**RE: Comments on Tentative Order No. R9-2004-0154, Waste Discharge
Requirements for Duke Energy South Bay LLC**

Duke Energy South Bay LLC ("Duke Energy") hereby submits the following comments on the Tentative Order No. R9-2004-0154, NPDES permit No. CA0001368, for the South Bay Power Plant ("SBPP").

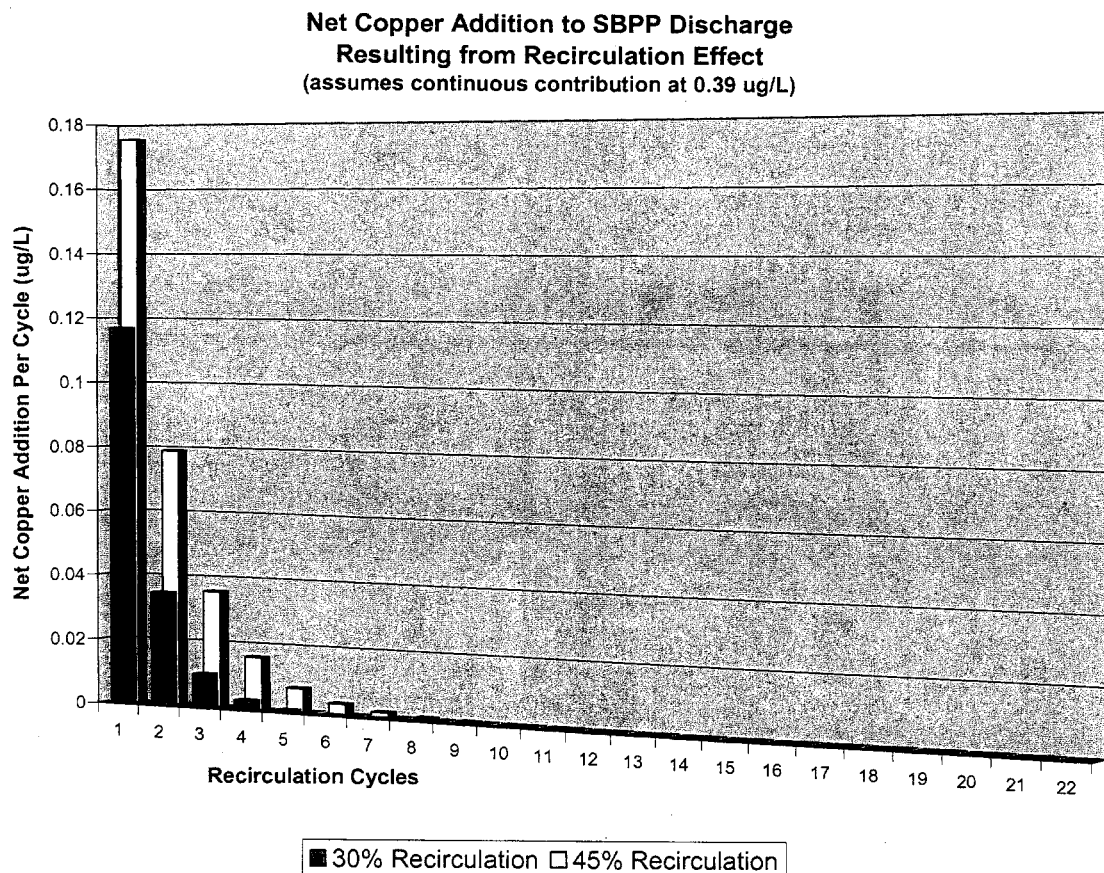
The following figure illustrates the changes in ambient copper concentration in the SBPP discharge as a result of the circulation effect. This assumes a continuous discharge rate for copper of $0.39 \mu\text{g/L}$ (the estimate from the SDG&E copper study) and covers a range of plume recirculation from 30% to 45% (the estimates from the Merkel/Jenkins report). The chart clearly shows that any measurable concentrating effect from recirculation of the discharge plume occurred in the first few recirculation cycles, i.e., in 1960, when the plant was first commenced operation.

The net additional ambient copper concentration is the sum of the values for each recirculation cycle. At 30% recirculation, the net addition to the ambient copper concentration over the entire life of the power plant is less than $0.17 \mu\text{g/L}$ and at 45%, the net is less than $0.32 \mu\text{g/L}$. This increase in concentration is within the range of analytical uncertainty given the ambient concentration of total copper is typically 10 to 100 times higher. Thus, the recirculation effect simply does not merit consideration and any continuing refusal to recognize intake credits based on this concern would be unwarranted.
